Approved Section 75W Modification Application

No. MP 10-0027 MOD1 granted on the 24 JULY 2012

Revision E - Section 75W Amendments

Site 3
Sydney Olympic Park
Plan
Basement 001

**Site 3
Sydney Olympic Park**
 Plan
 Level 19-21

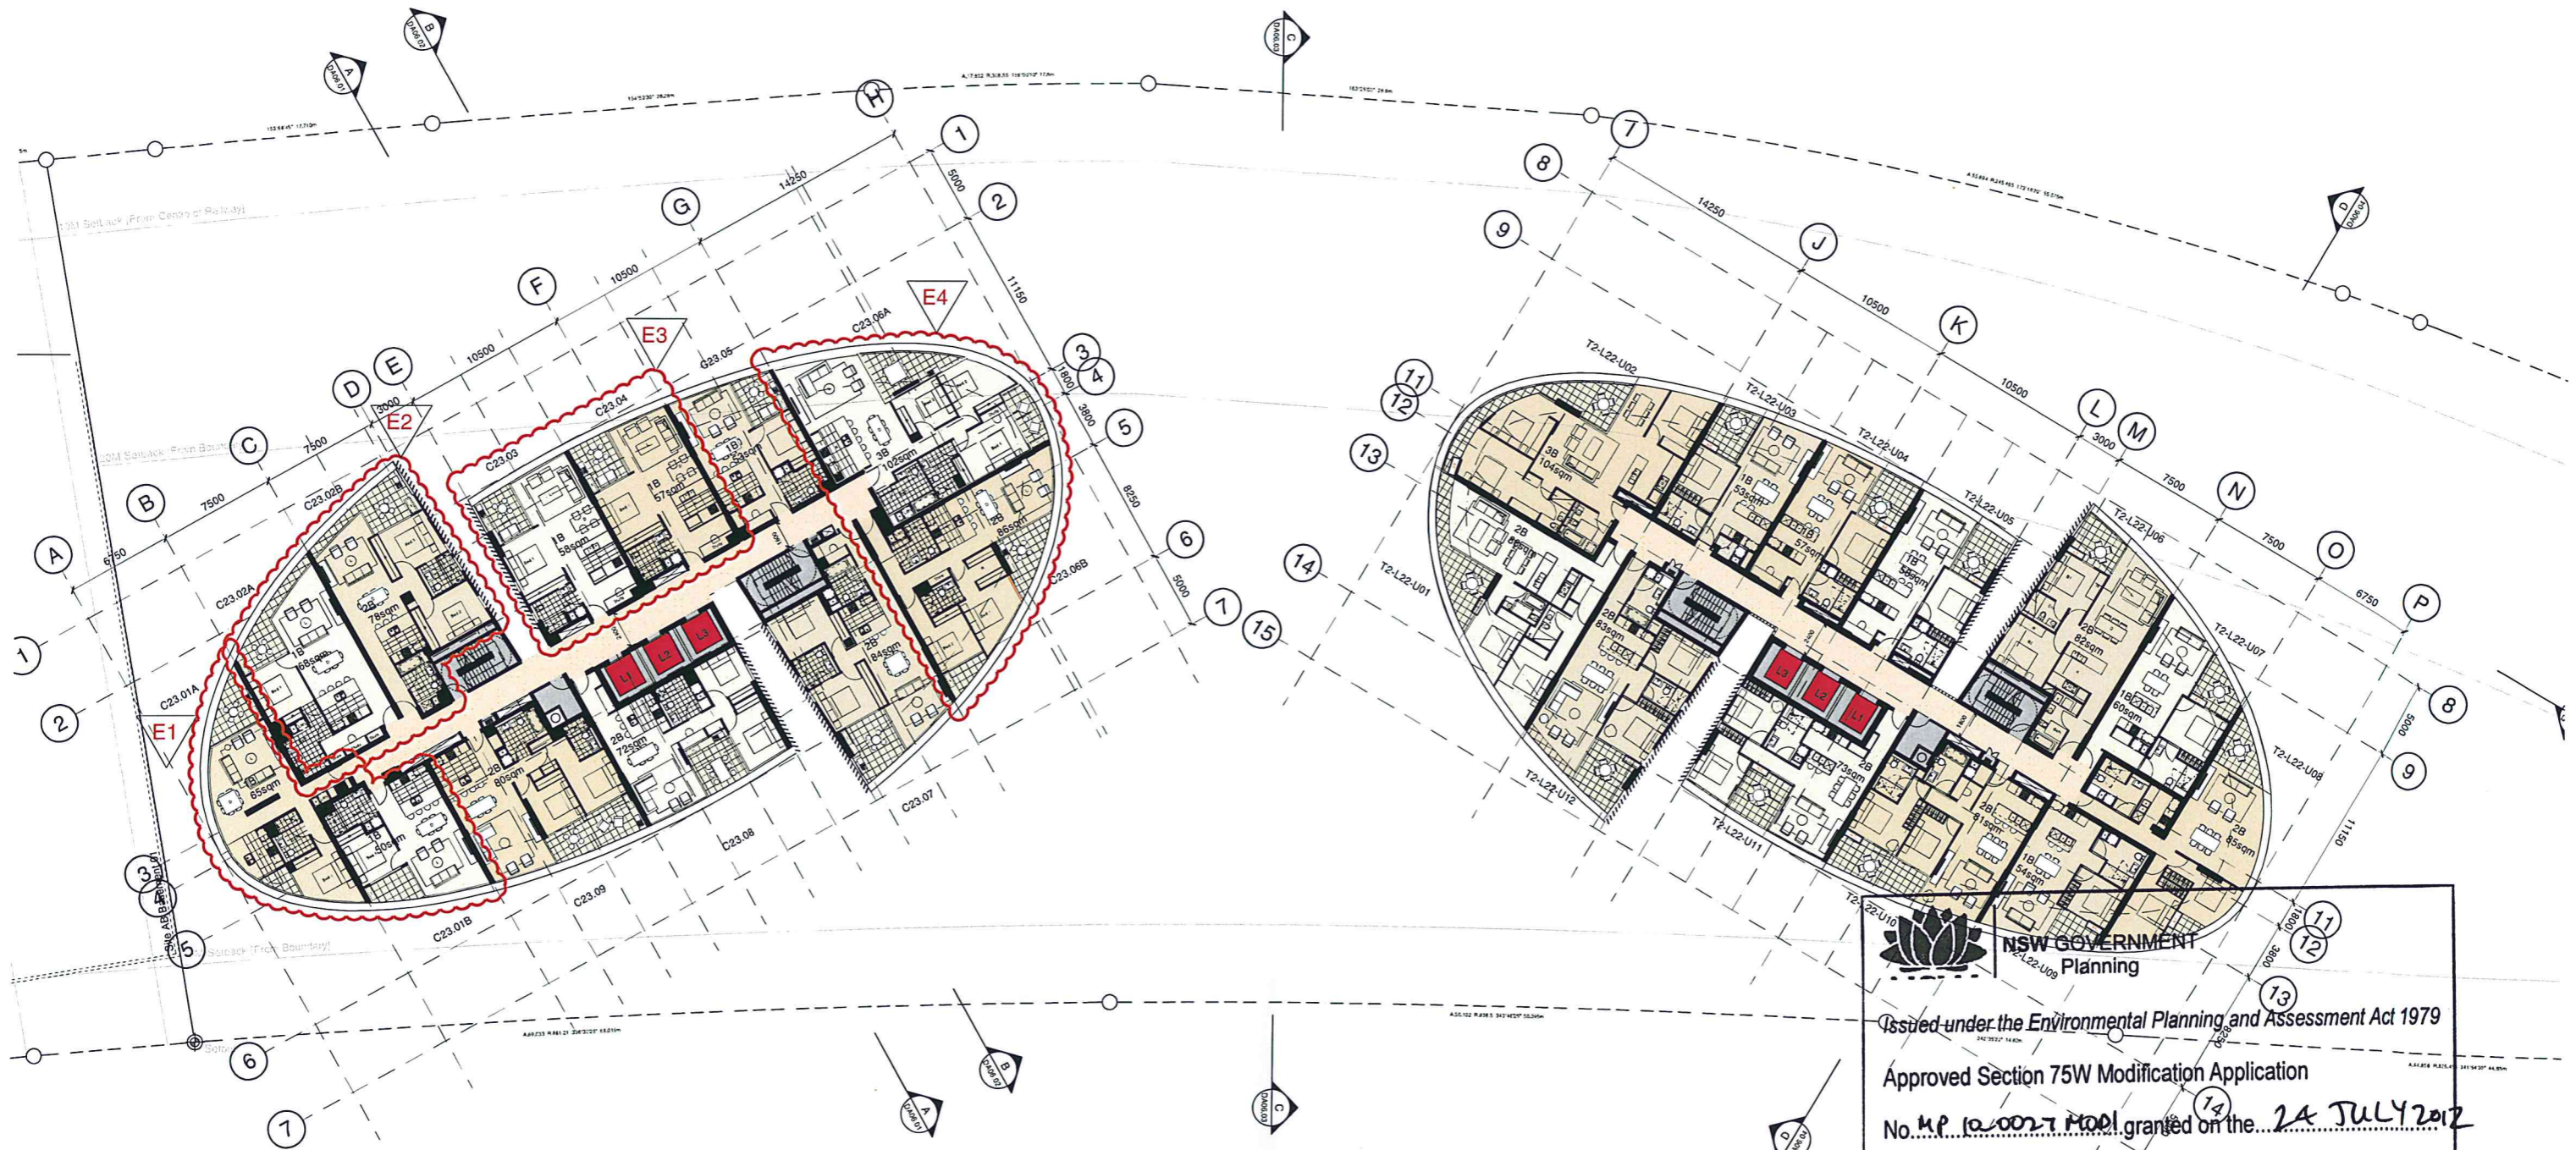
Revision E - Section 75W Amendments
 1. Change of apartment mix from one 3-Bed (C14.01-C22.01) to two 1-Bed (C14.01A-C22.01A & C14.01B-C22.01B).
 2. Apartments C14.04-C22.04 & C14.05-C22.05 have been allocated as adaptable units.

Site 3
Sydney Olympic Park
Plan
Level 22

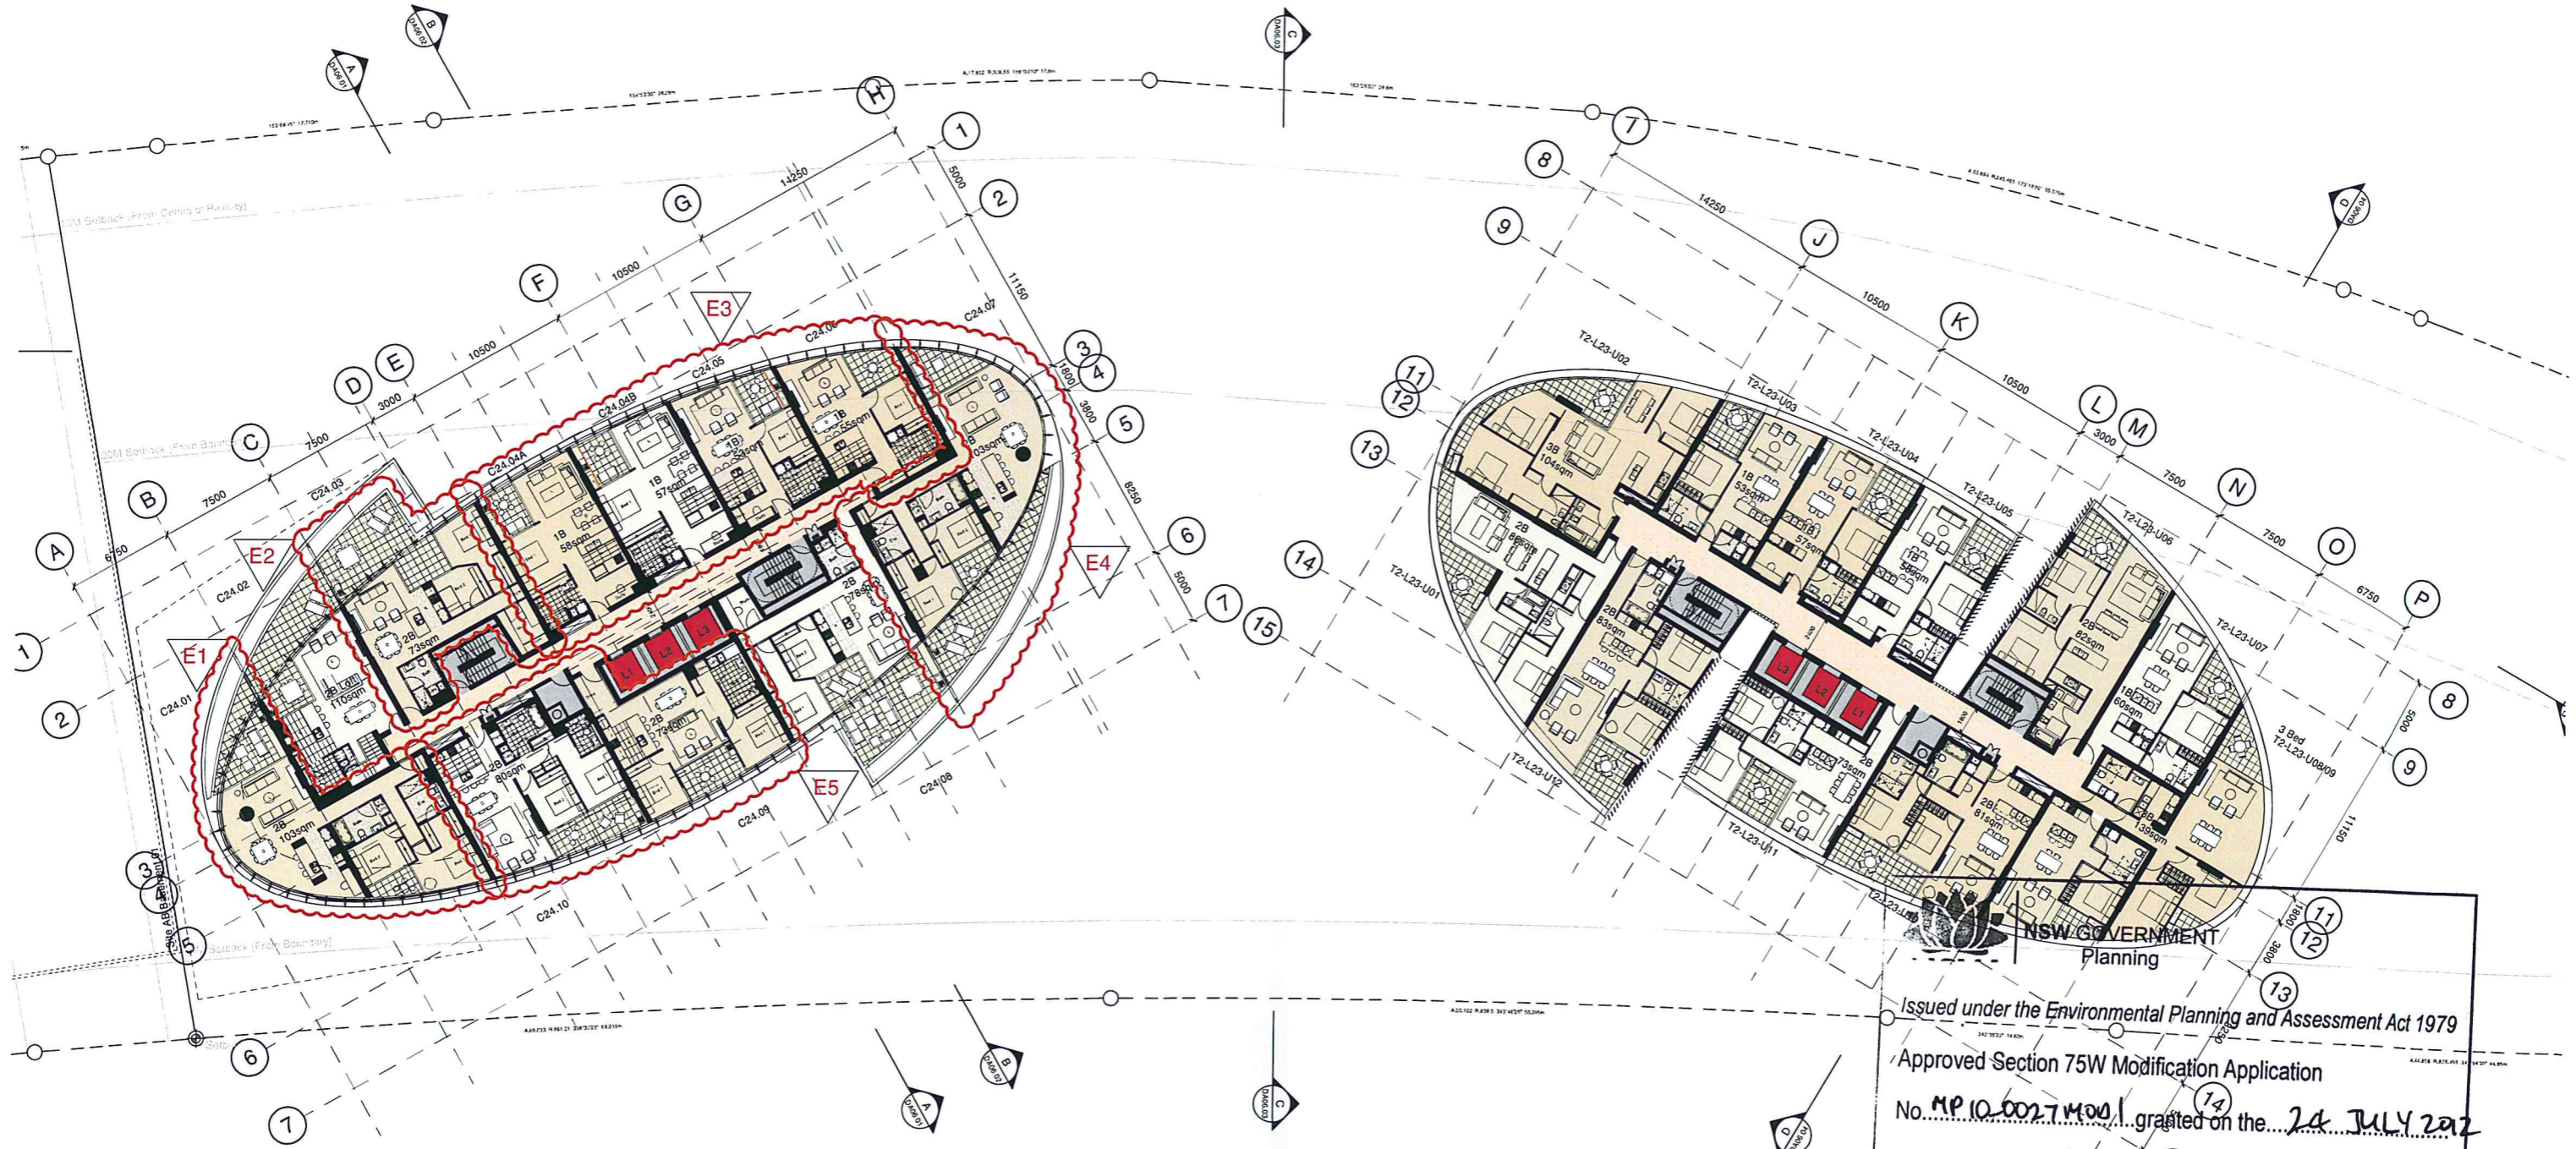
- Change of apartment mix from one 3-Bed (C23.01) to two 1-Bed (C23.01A & C23.01B).
- Change of apartment mix from one 3-Bed (C23.02) to one 1-Bed (C23.02A) and one 2-Bed (C23.02B).
- Apartment C23.04 & C23.05 have been allocated as adaptable units.
- Change of apartment mix from one 4-Bed (C23.06) to one 2-Bed (C23.06B) and one 3-Bed (C23.06A).

**Site 3
Sydney Olympic Park
Plan
Level 23**

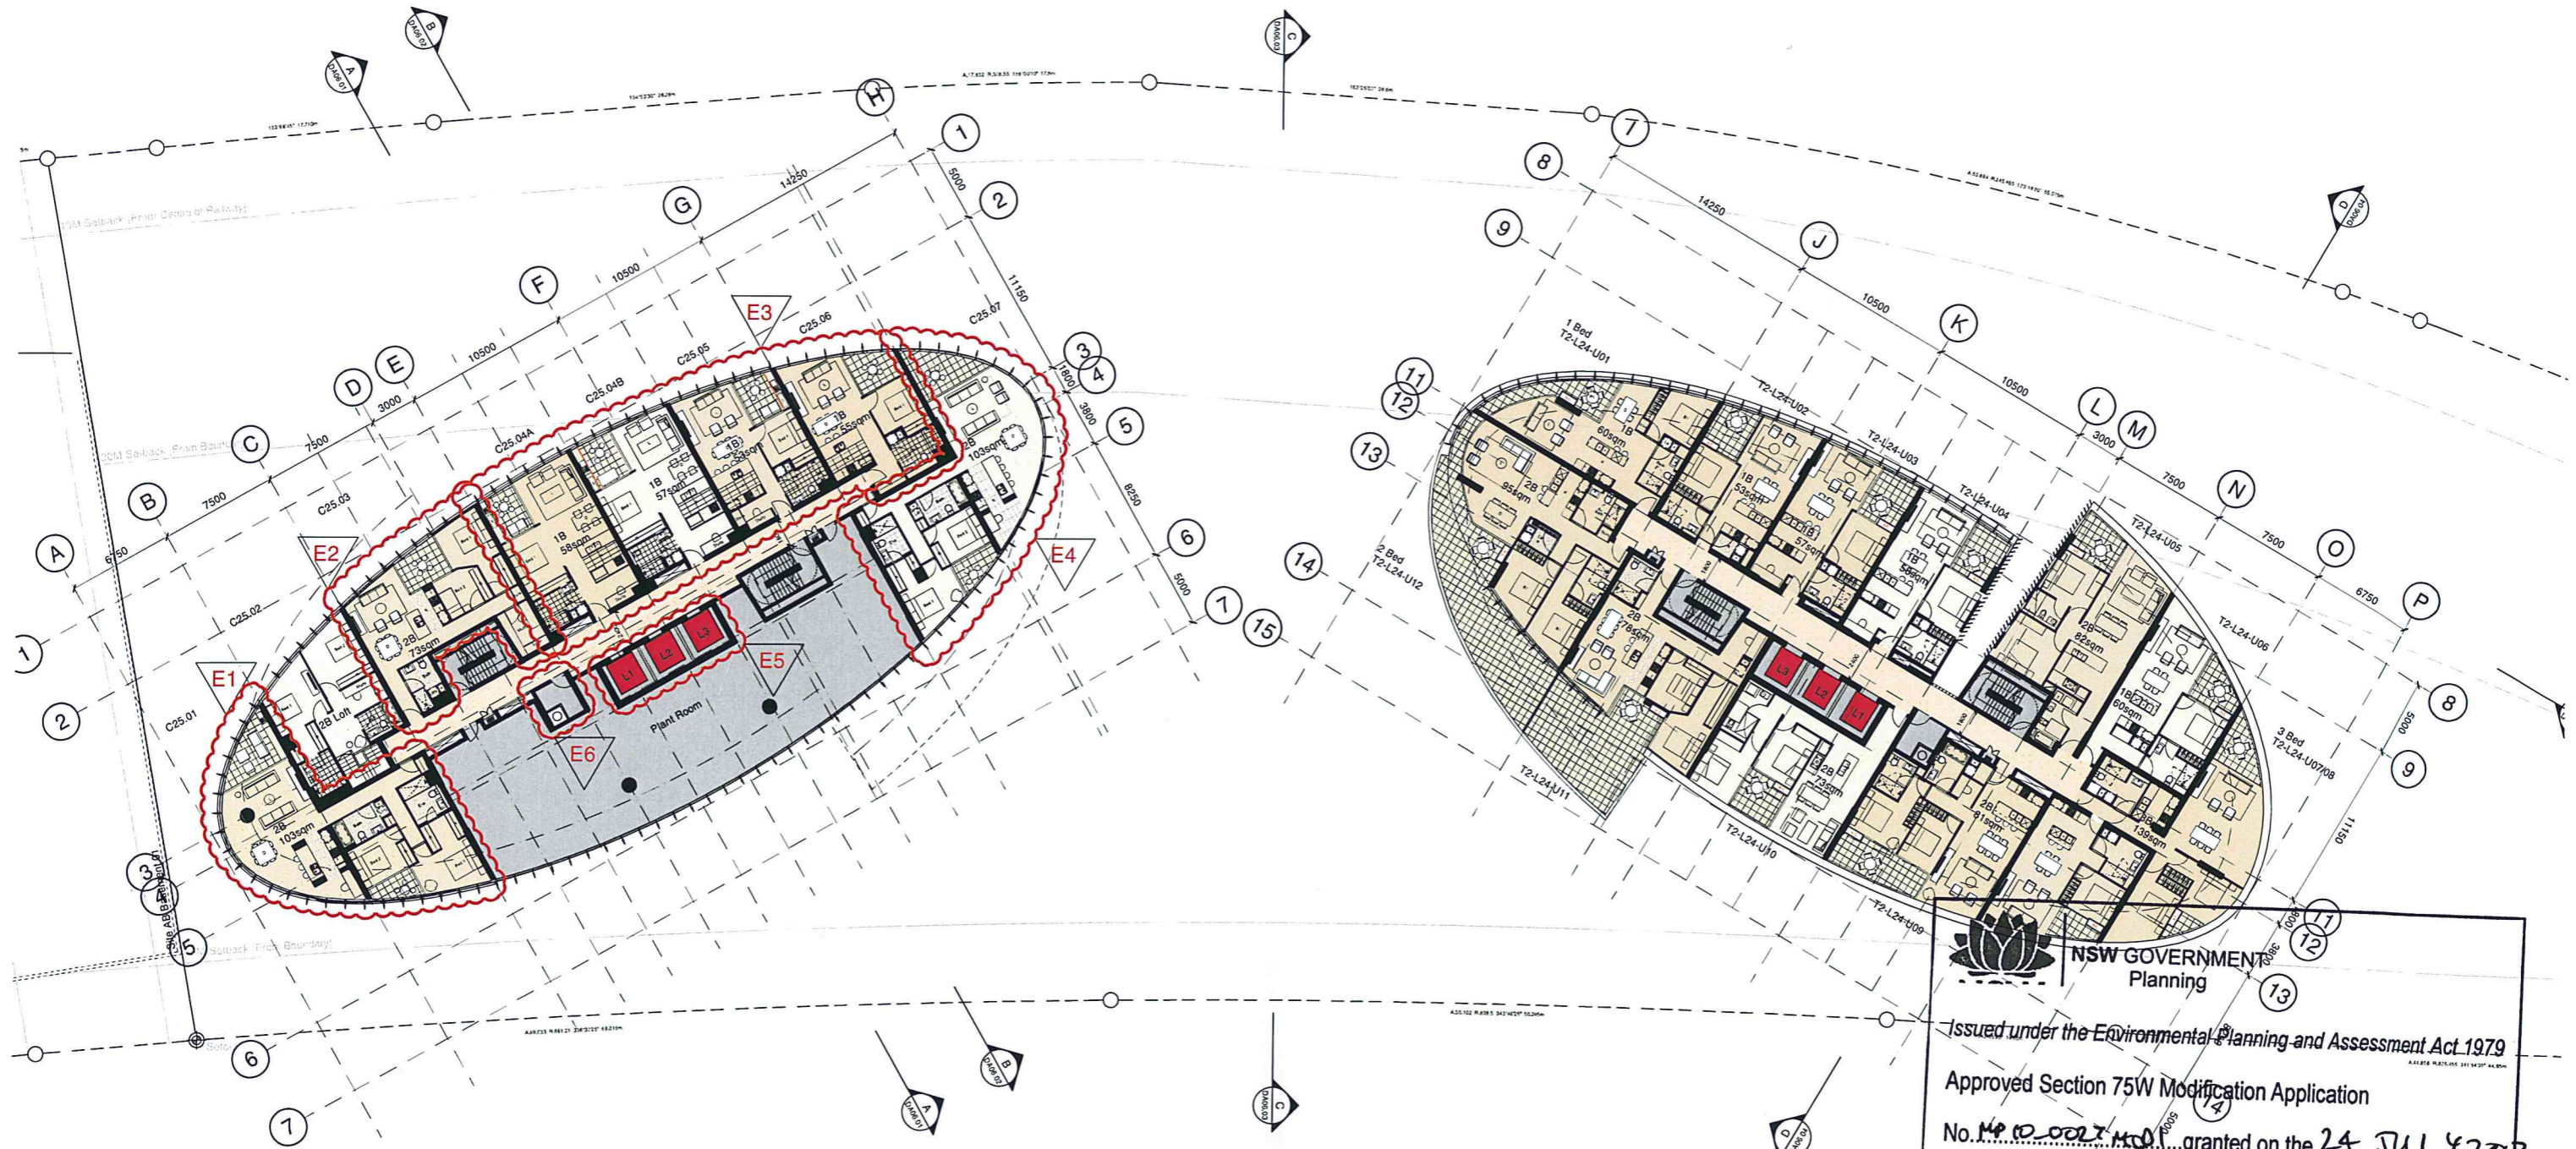
- Revision E - Section 75W Amendments**
1. One 3-Bed Lot (C25.01) has been modified to one 2-Bed single storey apartment (C24.01).
 2. One 3-Bed Lot (C25.03) has been modified to one 2-Bed single storey apartment (C24.03).
 3. One 2-Bed Lot and two 4-Bed Lots (C25.04, C25.05 & C25.06) have been modified to four 1-Bed single storey apartments (C24.04A, C24.04B, C24.05 & C24.06), including two units allocated as accessible units.
 4. One 3-Bed Lot (C25.07) has been modified to one 2-Bed single storey apartment (C24.07).
 5. Change of apartment mix from one 1-Bed and one 3-Bed (C25.09 & C25.10) to two 2-Bed (C24.09 & C24.10).
